**Reply Testimony of Doris Mast (Doris Mast/200)**

I offer the following reply testimony to the testimony of PUC Staff. My testimony is organized by the portion of the Staff testimony to which I am replying.

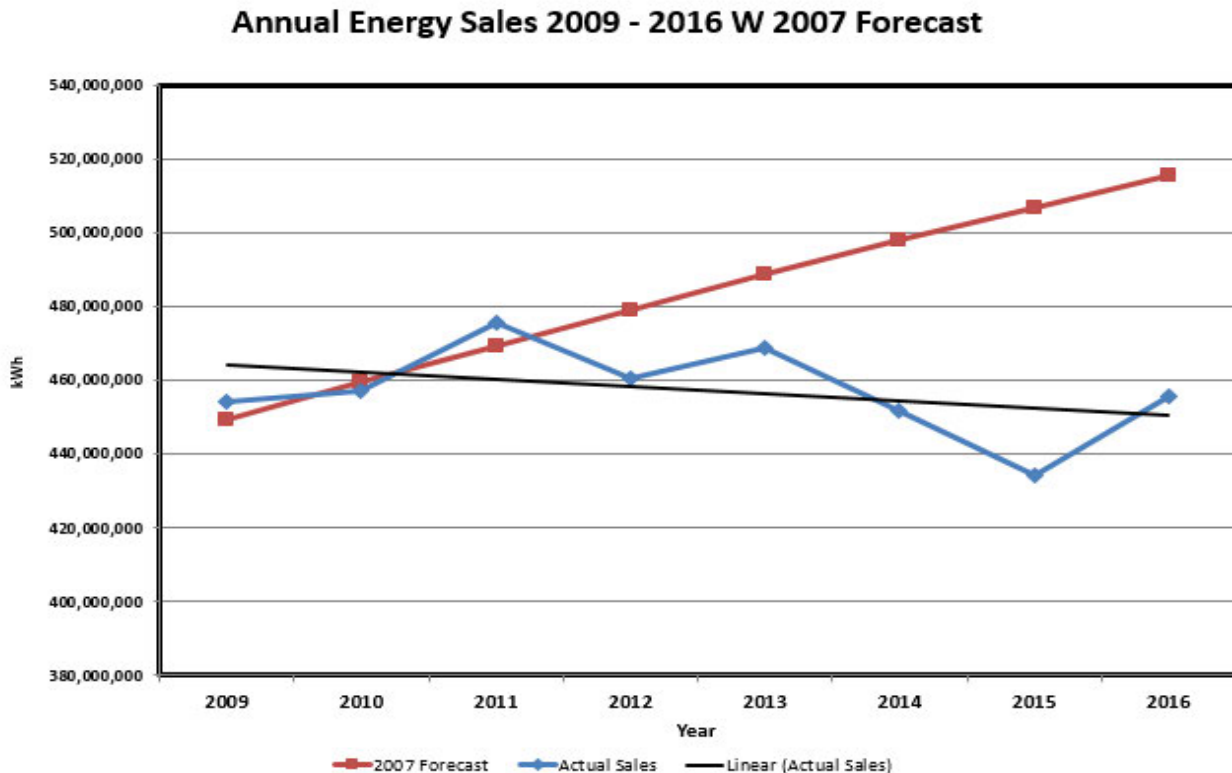
Lines 11 – 14 in staff/200 Hanhan/11 regarding N – 1 contingency analysis are incorrect. DR-21, Sheet 2 is a spreadsheet from TPUD showing their calculations. If you compare the capacities of all of these models to the chart provided in TPUD’s response to DR-32, you will see that the capacities used come from the 2<sup>nd</sup> column from the left titled Nameplate Capacity 2018 (Top MVA Rating).

Since none of the calculations provided use the capacity from either the 2014 Winter Capacity Column nor the 2018 Winter Capacity Column, the statement that the loading is at 92% of combined winter capacity is wrong. TPUD's N – 1 data in DR-21 Sheet 2 cells A2-D7 represents a 2009 load and was TPUD's all-time system high. You can correctly say that the T1 is at 93% of individual transformer loading prior to the N – 1 because the capacity used is from the nameplate capacity column. In cells A9 – D15 and cells F10 – I15 the T2 is removed and the T2 load is redistributed. You can correctly say that the Garibaldi, T1 and Trask transformers are loaded at 92% of transformers capacity. The total capacity is 140.
